Access Compliance Report

Public Rights-of-Way

(Curb Ramps)

Intersection ID: 29120	Main Street: BEARD_RD	Cross Street: APPLEDALE_DR	Location: E
ADA ID: E593232E3C52	Ramp Type: PerpDiag	Initial Pass/Fail: Fail	Overall Compliance: No
		Severity Score: 22.5

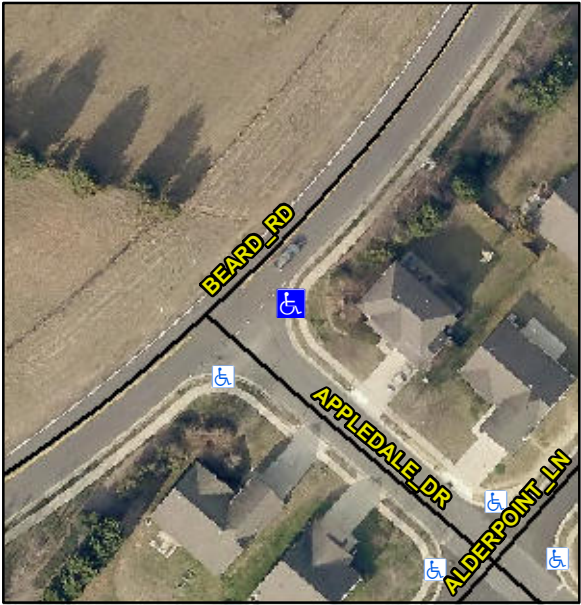
Codes/Mitigation Info/Possible Solution			Field Measurements/Component Compliance		
	Possible Solutions:		Compliance	Description	Data
	Remove & Replace Curb Ramp With Two New Directional Ramps or Equivalent.		No	Ramp Length (in)	44.0
			No	Ramp Width (in)	41.0
			N/A	Flare Type LT	N/A
			N/A	Flare Slope LT (%)	N/A
			N/A	Flare Traversable LT?	N/A
			N/A	Landing Length (in)	N/A
			N/A	Landing Width (in)	N/A
			N/A	Landing Slope (%)	N/A
			N/A	Landing X Slope (%)	N/A
			N/A	Landing Curb? (Y/N)	N/A
			N/A	Shared Landing?	N/A
			N/A	Gutter Ponding?	N/A
			N/A	Gutter Lip Ht (in)	N/A
			No	Painted X Walk1?	N/A
				X Walk 1 Direction	To NW
			N/A	X Walk 1 Width (in)	N/A
				X Walk 1 Slope (%)	6.2
				X Walk 1 X Slope (%)	5.4
			N/A	Ramp inside XWalk1?	N/A
<p>Surveyor Notes:</p> <p>N/A</p> <p>PROW/ADA:</p> <p>R304.5.1, R304.2.2, R304.5.3</p>			N/A	Flare Type RT	N/A
			N/A	Flare Slope RT (%)	N/A
			N/A	Flare Traversable RT?	N/A

N/A	DWS Provided?	N/A
			N/A	DWS Contrast?	N/A
			N/A	DWS Length (in)	N/A
			N/A	DWS Full Width?	N/A
			N/A	DWS Offset (in)	N/A
			N/A	Gutter Slope (%)	N/A
			N/A	Gutter X Slope (%)	N/A
			No	Painted X Walk2?	No
				X Walk 2 Direction	To SW
			N/A	X Walk 2 Width (in)	N/A
				X Walk 2 Slope (%)	5.3
				X Walk 2 X Slope (%)	2.7
			N/A	Ramp inside XWalk2?	N/A
			N/A	Clear Space?	N/A
			N/A	Clear Space to XWalk (in)	N/A
			N/A	Storm Grate/Utility Hazard?	N/A
				Storm Grate/Utility Type	
<p>Total Cost:</p> <p>\$ 3200.00</p>			N/A		N/A
			Yes	Surface Condition? (G/P)	Good
